Access Compliance Report

Public Rights-of-Way

(Curb Ramps)

Intersection ID: 44786	Main Street: AYRSLEY_TOWN_BV	Cross Street: KINGS_PARADE_BV	Location: NE
ADA ID: 2537FF37DDC4	Ramp Type: Perp	Initial Pass/Fail: Fail	Overall Compliance: No
Severity Score: 21.25			
Codes/Mitigation Info/Possible Solution		Field Measurements/Component Compliance

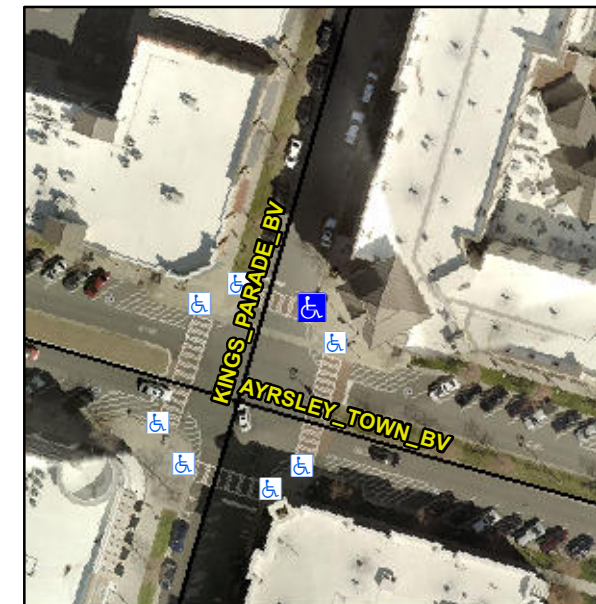
R304.5.1, R304.2.2

Compliance	Description	Data	Compliance	Description	Data
N/A	Ramp Length (in)	78.0	No	Ramp Slope (%)	11.0
No	Ramp Width (in)	45.0	Yes	Ramp XSlope (%)	2.0
N/A	Flare Type LT	N/A	N/A	Flare Type RT	N/A
N/A	Flare Slope LT (%)	N/A	N/A	Flare Slope RT (%)	N/A
N/A	Flare Traversable LT?	N/A	N/A	Flare Traversable RT?	N/A
N/A	Landing Length (in)	N/A	N/A	DWS Provided?	N/A
N/A	Landing Width (in)	N/A	N/A	DWS Contrast?	N/A
N/A	Landing Slope (%)	N/A	N/A	DWS Length (in)	N/A
N/A	Landing X Slope (%)	N/A	N/A	DWS Full Width?	N/A
N/A	Landing Curb? (Y/N)	N/A	N/A	DWS Offset (in)	N/A
N/A	Shared Landing?	N/A			
N/A	Gutter Ponding?	N/A	N/A	Gutter Slope (%)	N/A
N/A	Gutter Lip Ht (in)	N/A	N/A	Gutter X Slope (%)	N/A
N/A	Painted X Walk1?	Yes	N/A	Painted X Walk2?	N/A
	X Walk 1 Direction	To W		X Walk 2 Direction	N/A
N/A	X Walk 1 Width (in)	107.0	N/A	X Walk 2 Width (in)	N/A
	X Walk 1 Slope (%)	2.8		X Walk 2 Slope (%)	N/A
	X Walk 1 X Slope (%)	3.2		X Walk 2 X Slope (%)	N/A

Remove & Replace Entire Ramp.
